Rocky Creek Stage 5 – Response to Notice of Intent to
Refuse

Kroymans Developments Pty Ltd

Date: 21 August 2025

Figure 1 - Excerpt from Figure A.2 of 2024 Pinecrest Water & Sewerage Master plan - Stage 5A & 5B

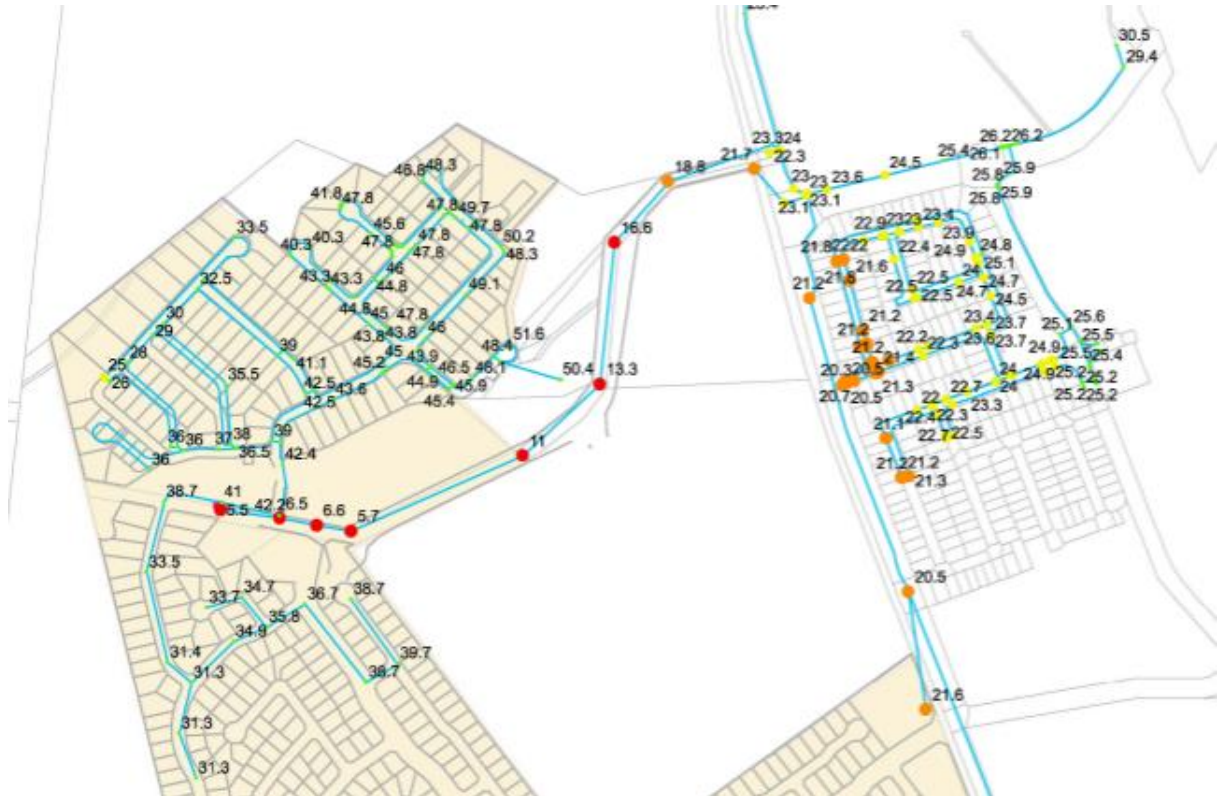
As can be seen in Figure 1 there are components of the Mt Peter's Estate with pressures that fall below the required FNQROC design standards of 22 m residual pressure because of this development.

By keeping the same demand scenario as Section 3.5.4 in the 2024 Pinecrest Water & Sewerage Master Plan – Stage 5A & 5B report and removing the Pinecrest Stage 2 loads of 384 EP which are beyond the scope of the study, the minimum pressures in the neighbouring Mt Peter's estate become compliant above 22 m (see below Figure 2).

Note, there are residual pressures < 22 m along the Pinecrest booster pump suction line. However there are no residential properties connected on this line and therefore this line is not required to meet FNQROC design standards.

Figure 3 - Long section of downstream sewer with Table 2 loads

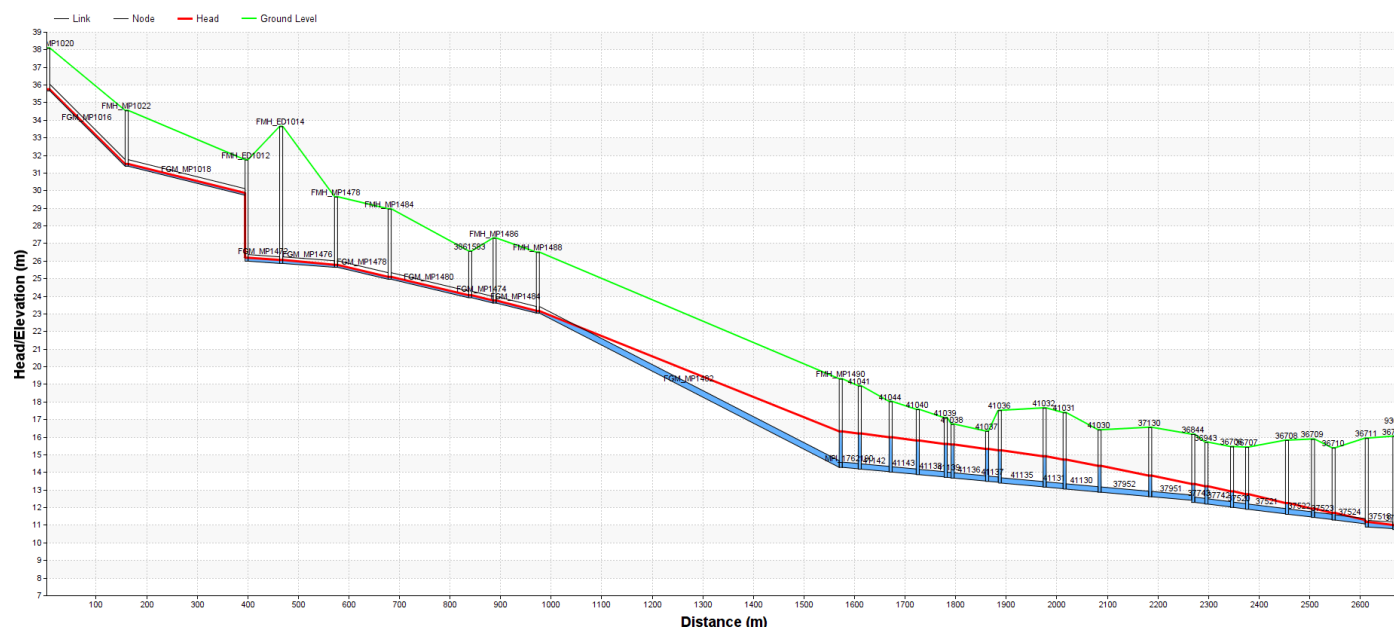
Through the above analysis it can be seen in Table 1 there was a difference of 148.19 EP, with an additional 70 EP capacity in the downstream trunk sewer. Thus, 78.19 EP of unrealised growth located outside of the PIA was required to be found. In Table 2, 94 EP of unrealised growth located outside of the PIA is found.

These loads were inputted into the sewerage model and the downstream trunk sewer was found to be within the CRC acceptable limits (> 1 m of freeboard). Figure 3 below shows the long section where the depth at the critical maintenance hole is 1.845 m allowing 1.007 m freeboard.
